Terminal connection changes:
MCFB with single part connectors to new style MCFB2 with two part connectors.

MTD MCFB2 T-B

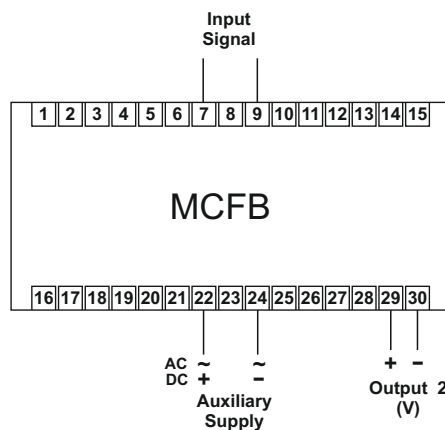
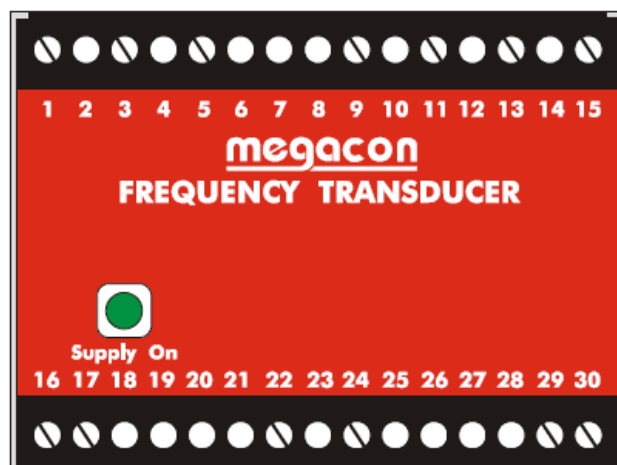
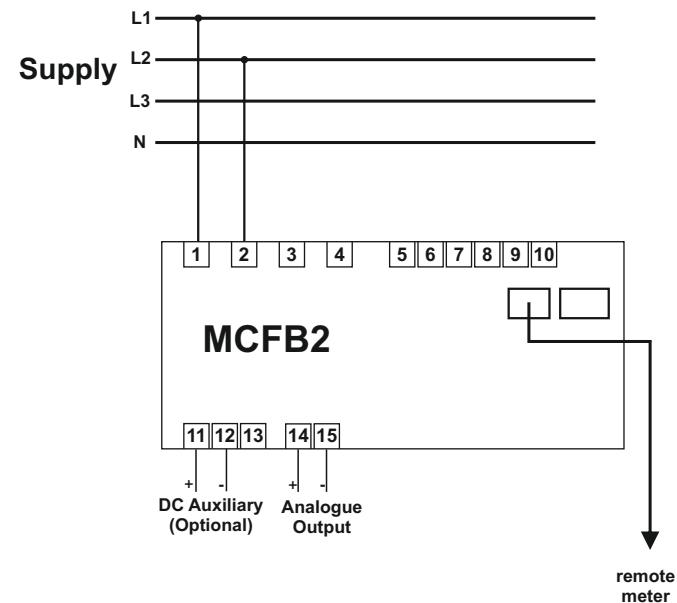
MCFB Terminal	MCFB2 Terminal
7	1
9	2
29	14
30	15
22	DC aux:11; AC aux: N/C
24	DC aux:12; AC aux: N/C
